PURBANI FASHION LIMITED

Kamarpara, Shernagar, Belkuchi, Sirajgong.
(24.282920, 89.688431)
15th March 2022

Observations

Foundation layout plan

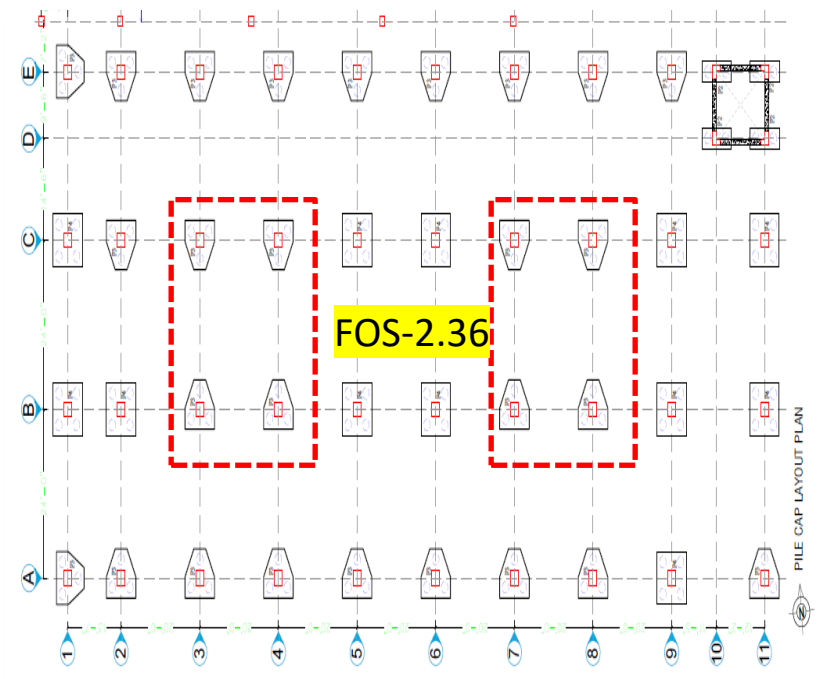
Foundation stress marginally exceeds the normal design limit

Cursory calculation indicates that the foundation stress marginally exceeds normal design limit for central column considering prepared live load plan and bearing capacity of foundation as per soil test report. Building engineer is required to review the design, load and foundation capacity.

Falling hazard at pump room stair

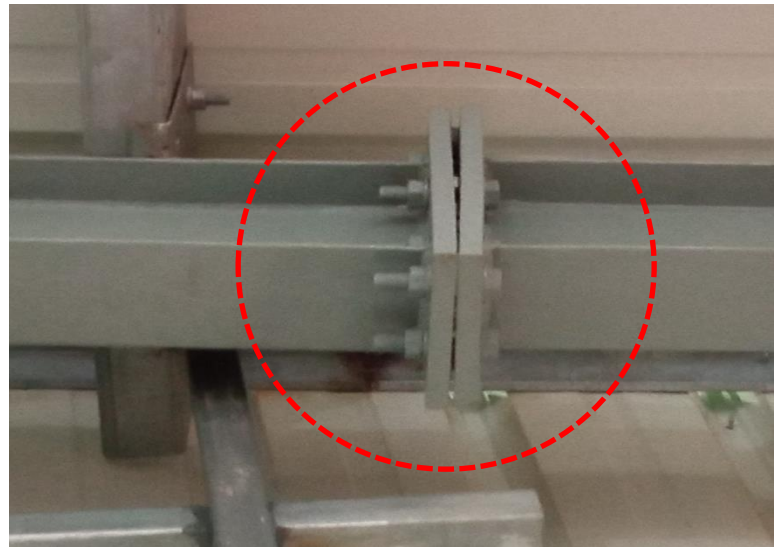
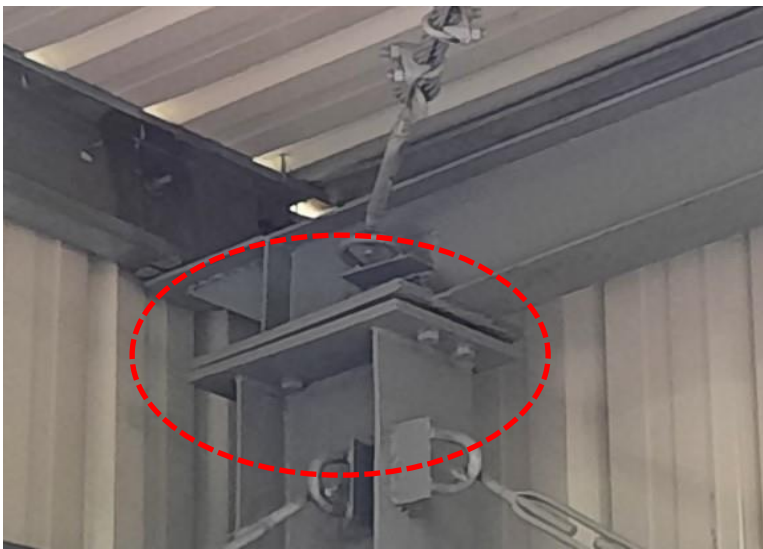
Falling hazard at pump room stair

Building engineer is required to provide protection barrier at stair edges.

Inconsistency in connection details

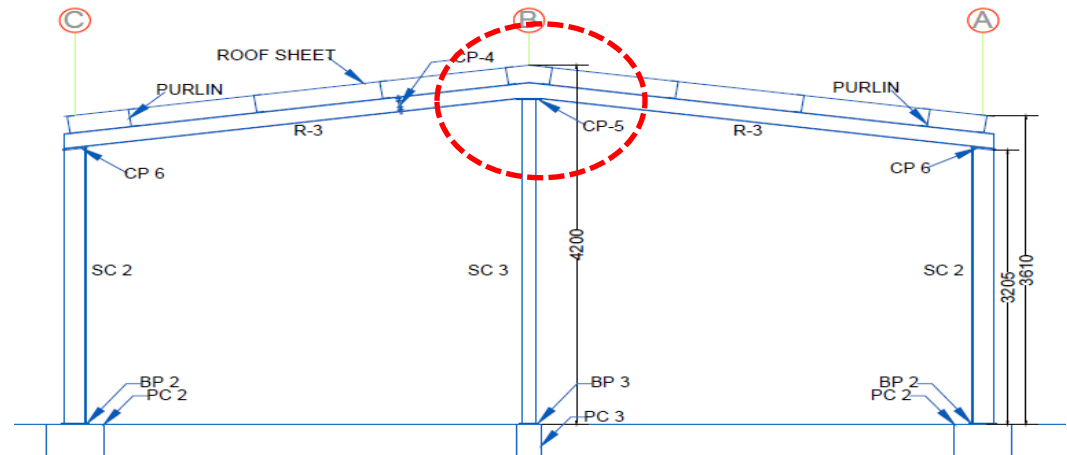
CP-4 = 275x150x16
8 nos Ø16 mm Bolt
Thick 16 mm

CP-5 = 225x175x16
6 nos Ø16 mm Bolt
Thick 16 mm

CP-6 = 300x225x16
8 nos Ø16 mm Bolt
Thick 16 mm

Building engineer to update the connection detail or install bolt as per structural drawings.

Existing beam dimension
(300x 500)

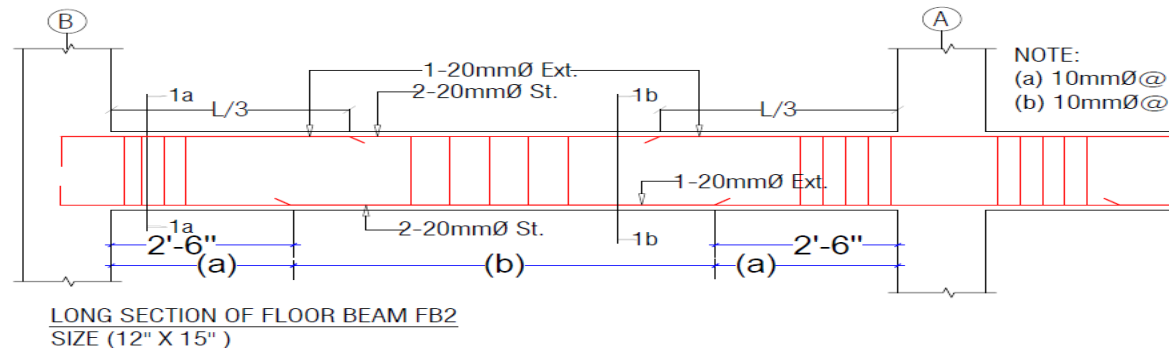
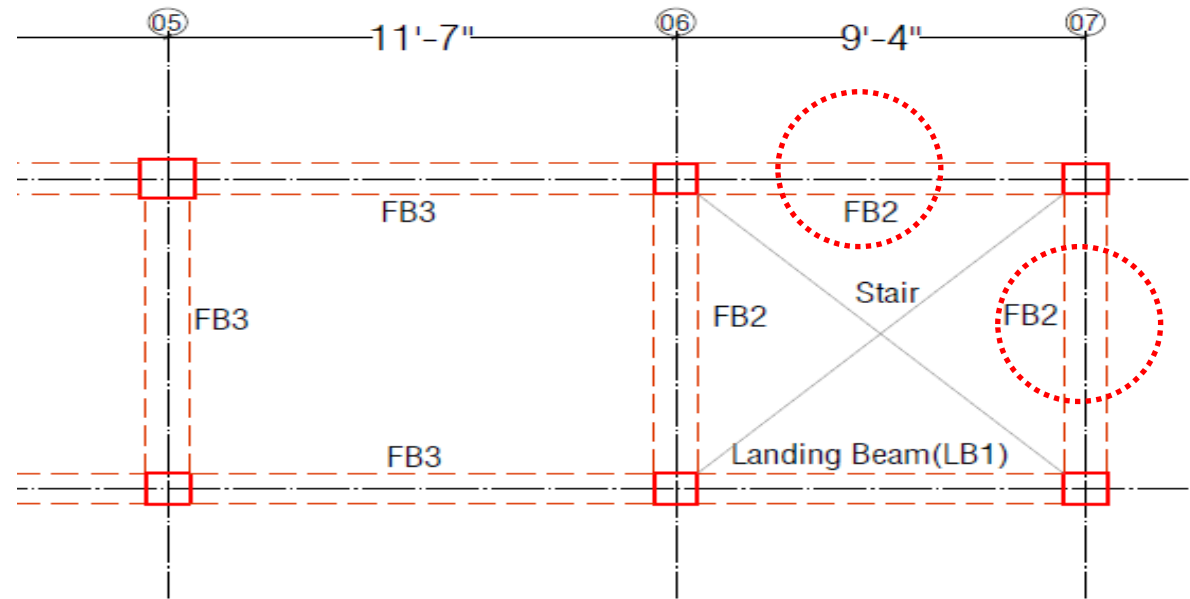
Existing beam dimension (FB-2-300x500) doesn't match with the as built structural drawing beam layout (FB-2-300x375). Building engineer to survey the structure and prepare accurate as-built drawings.
